Bayside Planning Panel

Item No	5.2
Application Type	Development Application
Application Number	DA-2017/131
Lodgement Date	15 October 2016
Property	4 Abercorn Street, Bexley NSW 2207
Owner	Ms M Manuela
Applicant	Ms M Manuela
Proposal	Construction of a two (2) storey dwelling house with basement, in-ground pool and demolition of existing structures
No. of Submissions	Nil
Cost of Development	\$680,000.00
Report by	Luis Melim – Development Services Manager

Planning Assessment Report

Application Number:	DA-2017/131
Date of Receipt:	15 October 2016
Property:	4 Abercorn Street, BEXLEY NSW 2207 Lot 1 DP 202344
Owner:	Ms Mariah Manuela
Applicant:	Ms Mariah Manuela
Proposal:	Construction of a two (2) storey dwelling house with basement, inground pool and demolition of existing structures
Recommendation:	Approval, subject to recommended conditions of consent
No. of submissions:	None
Author:	Creative Planning Solutions
Date of Report:	15 July 2017

Figure 1 – Extract of the Site Plan, illustrating duel frontage and allotment shape

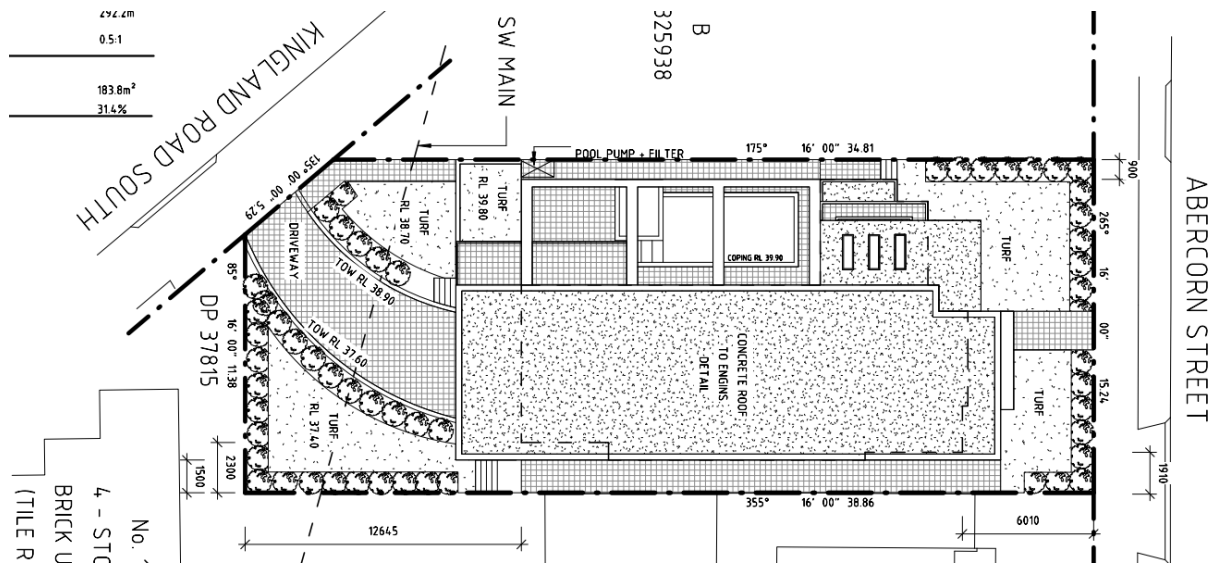
The site is afforded a dual frontage, with a primary frontage of 15.24 metres to Abercorn Street and a secondary frontage of 5.3 metres to Kingsland road South. The frontage to Kingsland Road South is set at an oblique angle to the general orientation

of the site which has resulted in the north-east corner being somewhat recessed. Refer to **Figure 1**.

Figure 7 - Diagram illustrating the proposed building envelope (approx.) overlayed on the submitted survey. The area of non-compliance is depicted by red shading.

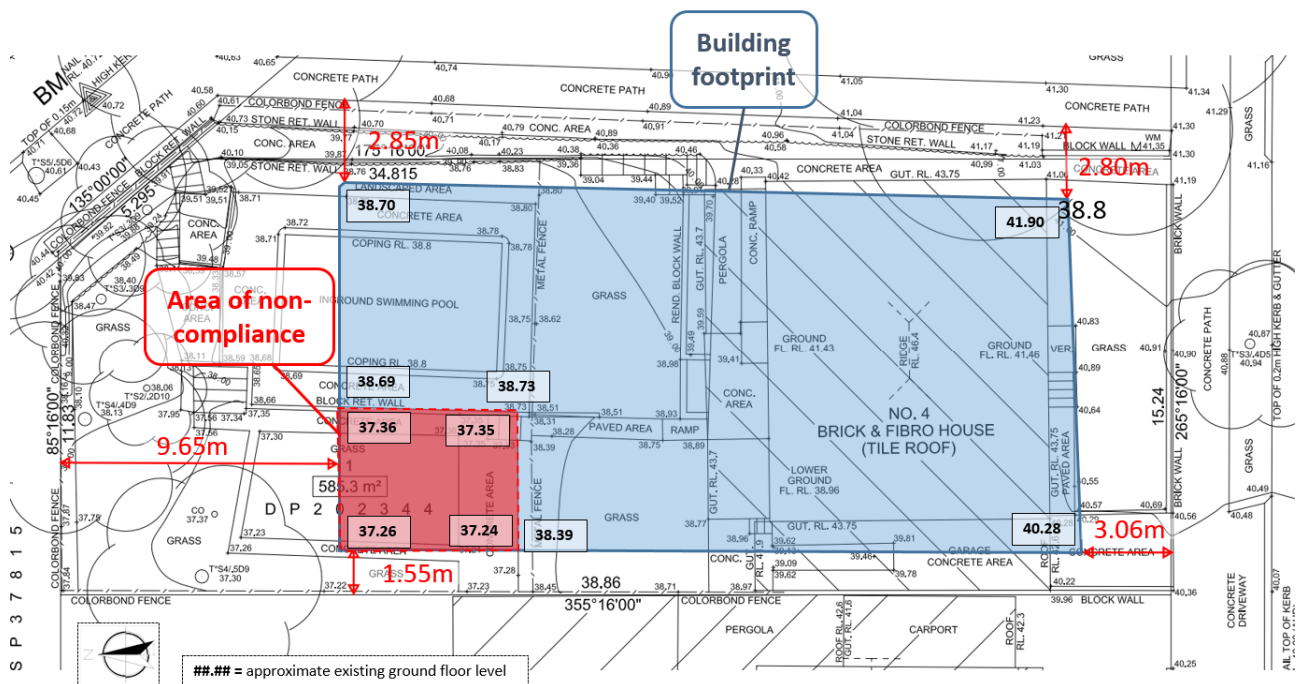
- a) The level of the height exceedance is numerically overstated. The land exhibits a north-south slope of 3.5m, and a cross slope of 2.6m at the cross section of height non-compliance. The angle of the slope accelerates at the northern section of the site, and is where the height exceedance occurs. In this regard, when considering the height exceedance in the context of the whole development, it is acknowledged that the area of the development that offends the height development standard is limited to 8% of the building foot print. Refer to **Figure 7**.
